STAFF REPORT
(One-Step Final Plat)

CASE NUMBER: SUB 2005-36 -- ALBERT FARM ADDITION

LOCATION: Southeast corner of Central and 151st St. West

VICINITY MAP

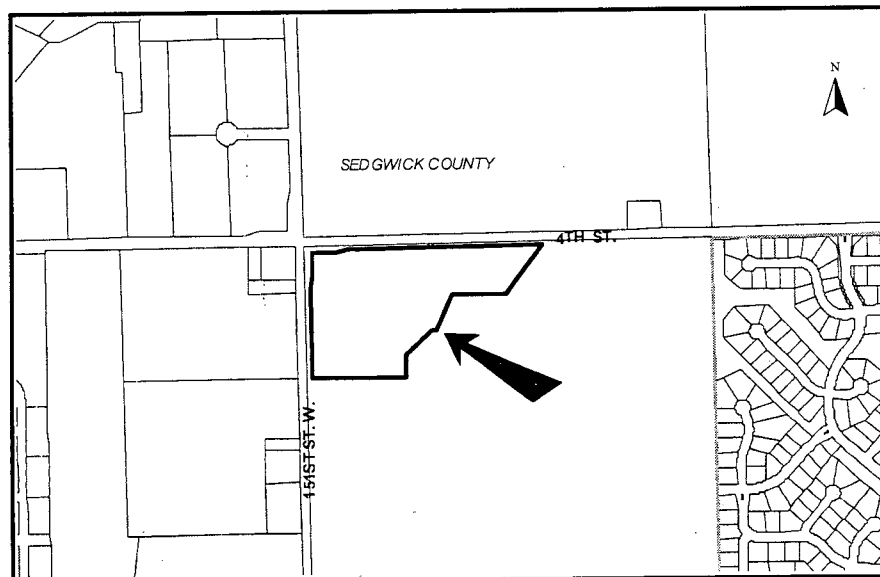
- C. **County Engineering** needs to comment on the status of the applicant's drainage plan. *A drainage plan and flood study are needed. Additional easements and minimum pads may be needed based on drainage plan. Applicant needs to remove existing terraces and show existing drainage structures on plat.*

- E. **County Engineering** has requested the major street right-of-way indicated on the plat be adjusted along both arterials. The Access Management Regulations requires a major street intersection to include a 75-ft half-street right-of-way measured 250 feet from the centerline of the intersecting arterials and a tapered length of 100 feet. An additional 25-ft x 25-ft corner clip is needed at the intersection.

- F. Access controls have been platted in accordance with the CUP approval. The plat proposes four access openings along Central, including three joint openings, and two joint openings along 151st St West. *The westernmost opening along Central needs to be a joint opening between Lots 5 and 6.*
